Submission
No 388

INQUIRY INTO IMPACT OF THE WESTERN HARBOUR TUNNEL AND BEACHES LINK

Organisation: Save Manly Dam Catchment Committee

Save Manly Dam Catchment Committee - Submission to the Inquiry into the Impact of the Western Harbour Tunnel and Beaches Link

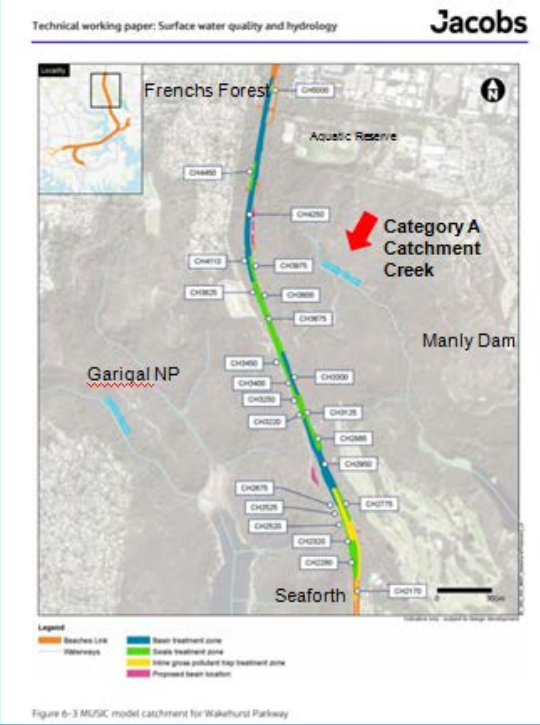
Drainage proposed by TfNSW for new widened road is inadequate.

Using TfNSW statistics it would have failed every month in 2020 against Terry Hills weather data – 35 mm over 5 days. Please re-design/re-investigate suitable drainage processes to protect this special area before asking for any approvals.

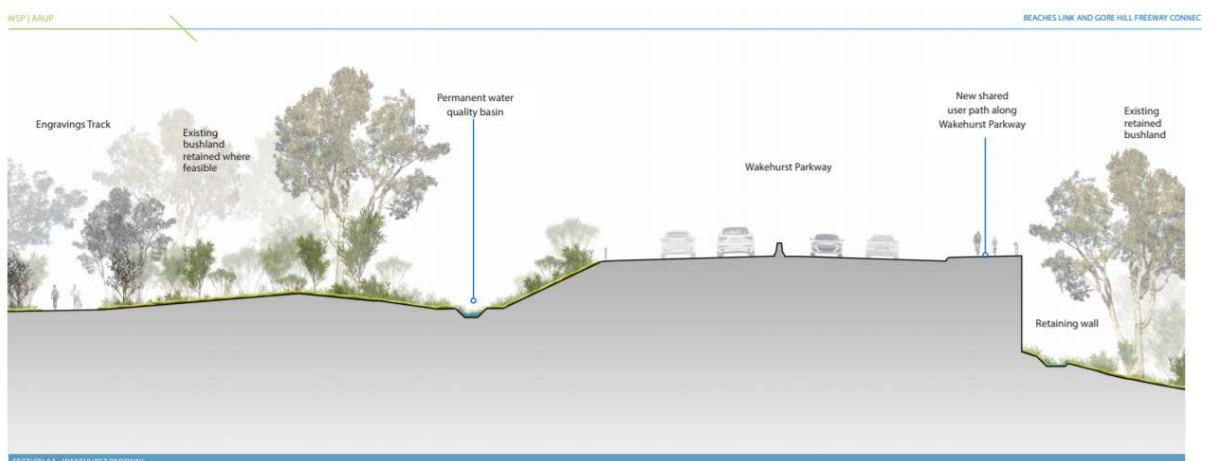
The proposed widened Wakehurst Parkway is built on a ridge.

In many cases the design includes the road being metres in the air. Please explain how the water run-off will be managed adequately, how the users of the shared pathway will be safe, and what extra damage will be caused by building on an unsuitable road? This is a cross section of Wakehurst Parkway. (Appendix v p190ish)

Please note the shared pathway (above the 6-10m retaining wall) with no safety features, no lights, no indication of separation from the 80km/hr vehicles.
